INDEX OF STRUCTURAL DRAWINGS

STATE OF HAWAII DEPARTMENT OF TRANSPORTATION HIGHWAYS DIVISION. INDEX OF STRUCTURAL DRAWINGS. INTERSTATE ROUTE H-1 AND H-201 DESTINATION SIGN UPGRADE/REPLACEMENT, PHASE 3B. FAP NO. NH-0300(205). Scale: None Date: Oct. 2023 SHEET No. S1.1 OF 5 SHEETS

**CANTILEVER BOX TRUSS SIGN STRUCTURE
 PLAN AND ELEVATION**

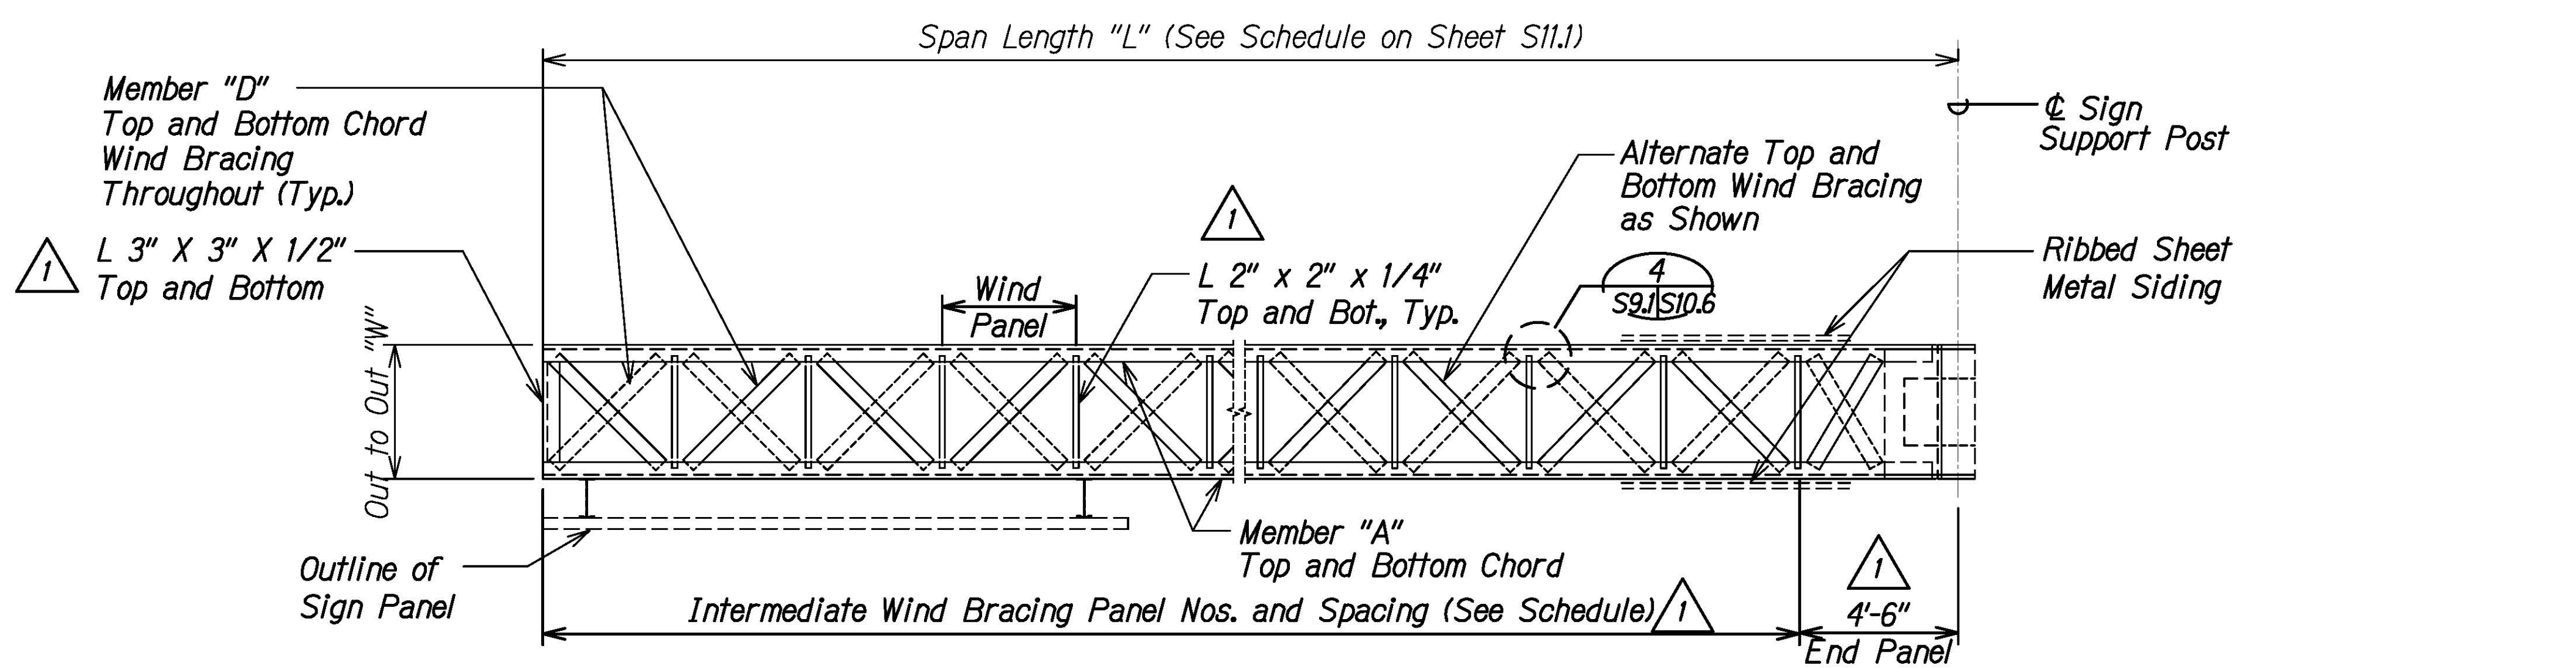
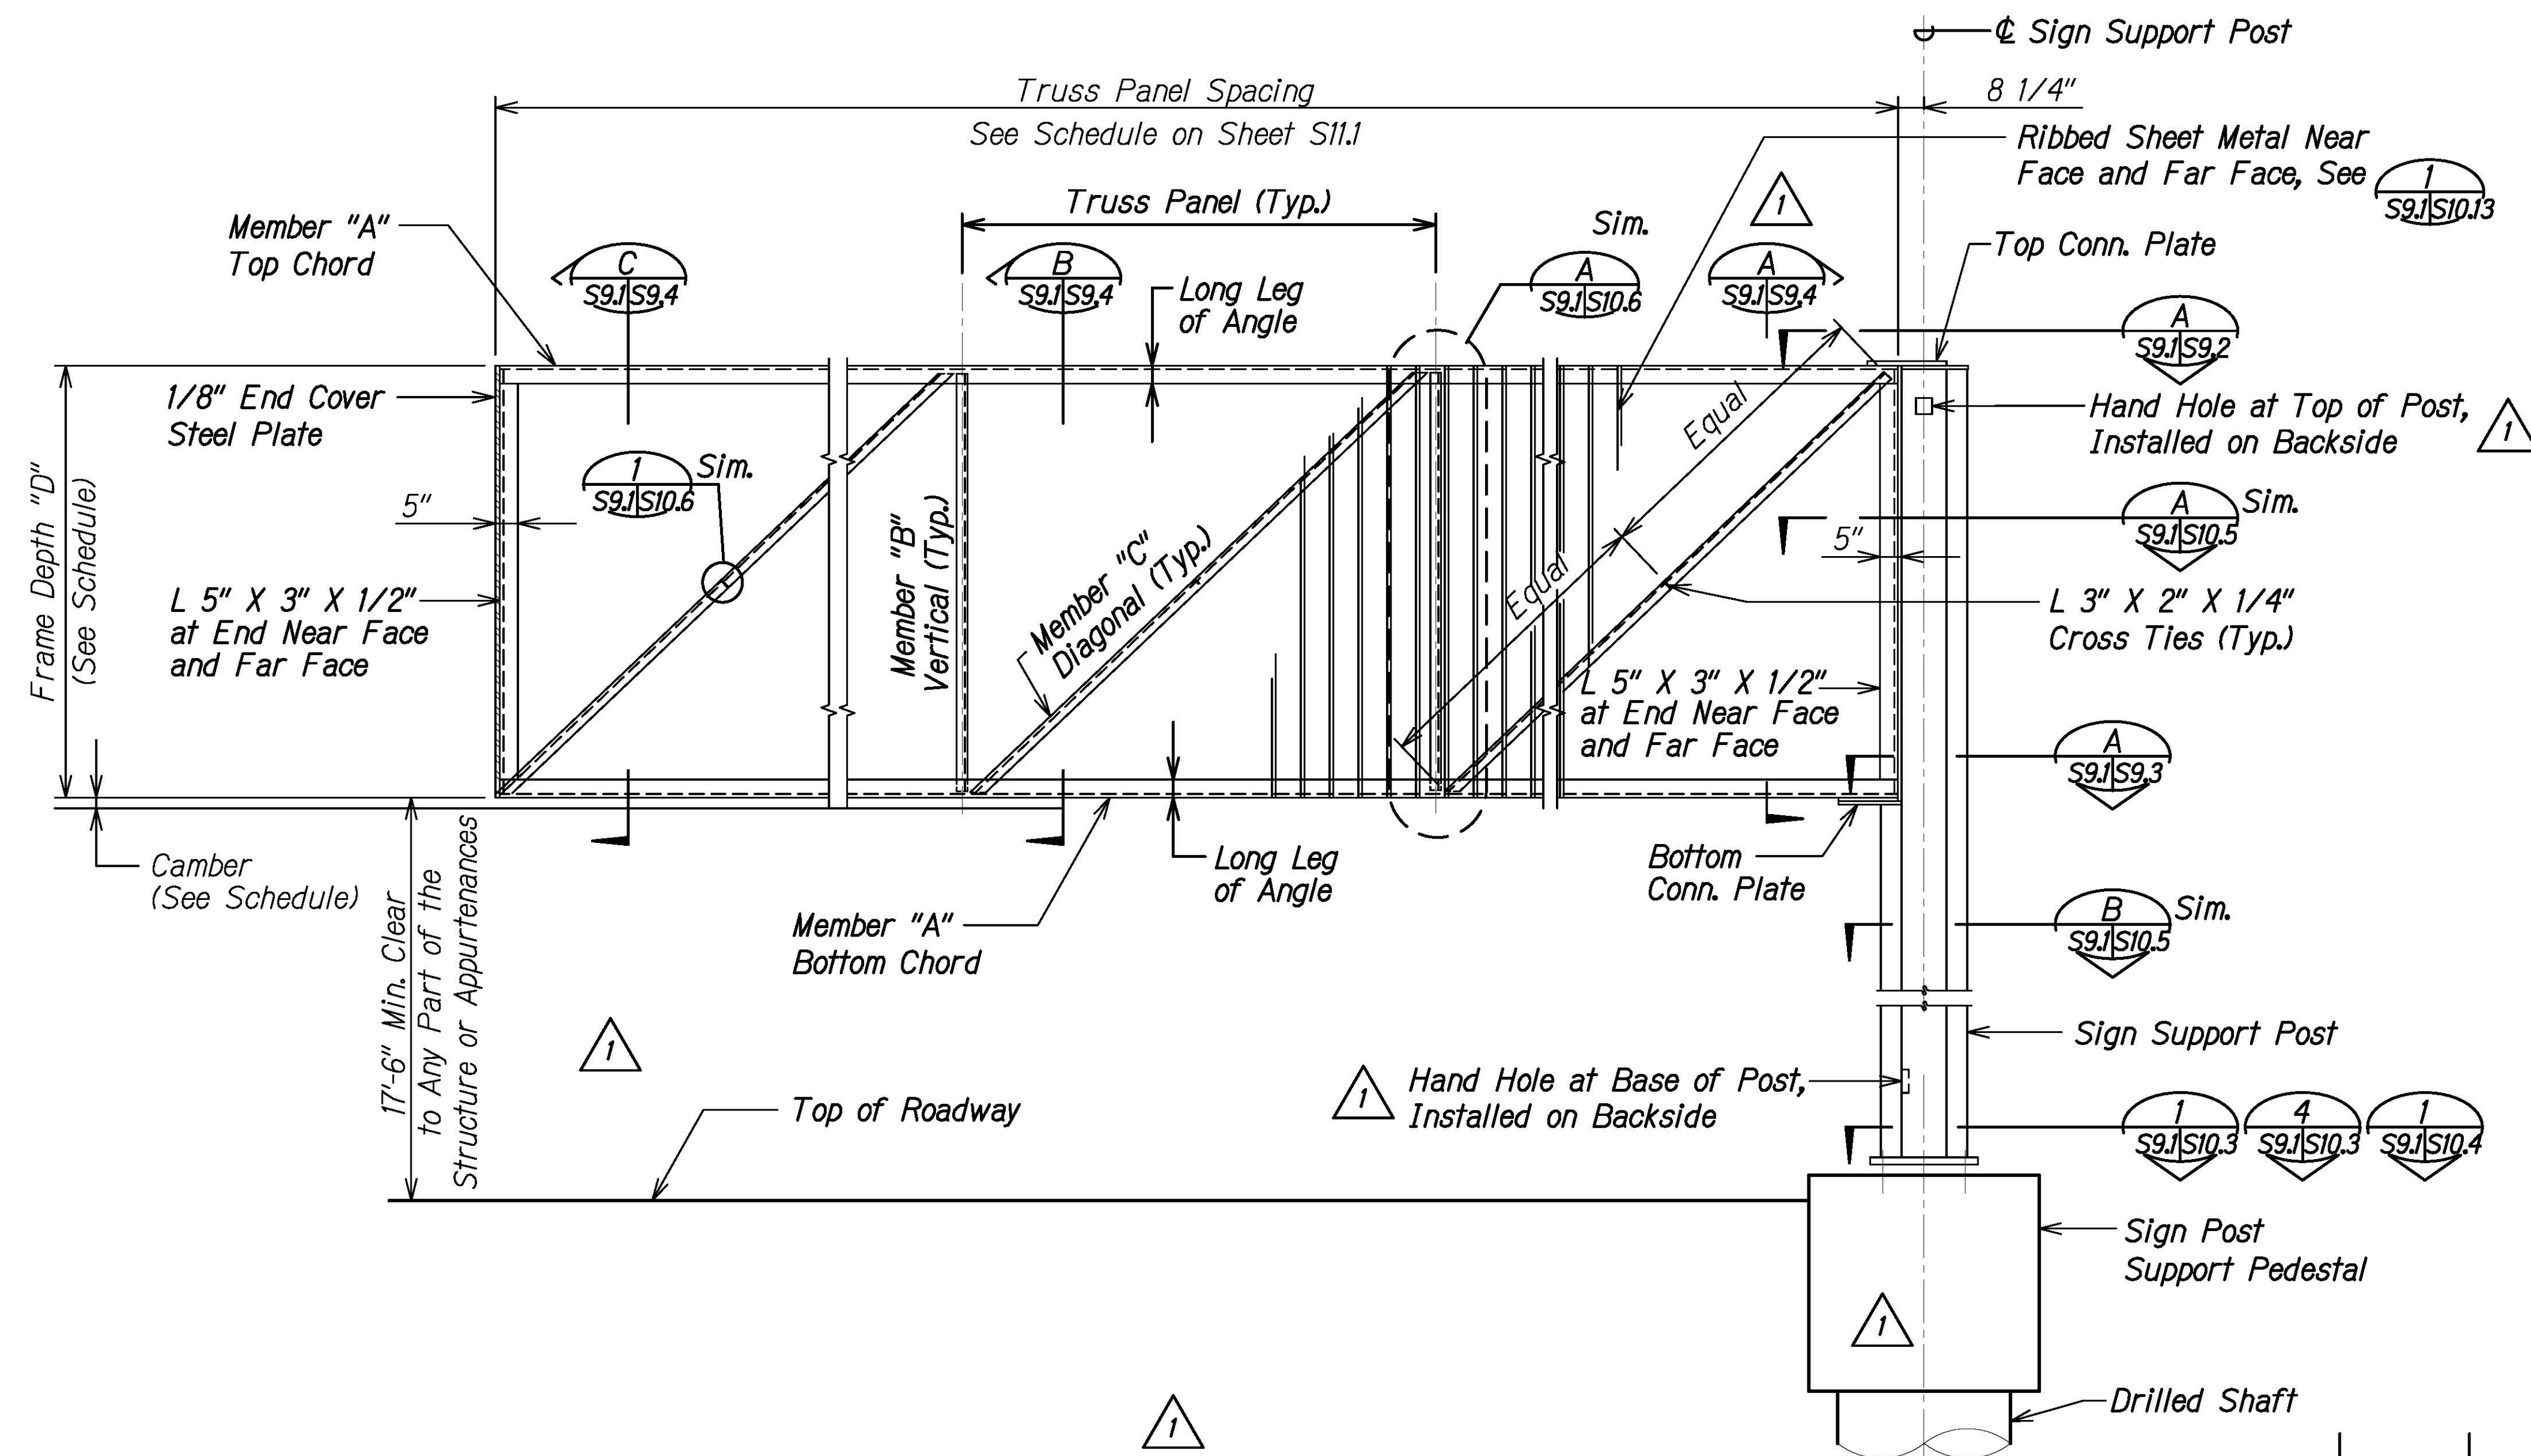
DATE	REVISION
1/25/24	1 Add. 1 - Revised Callouts
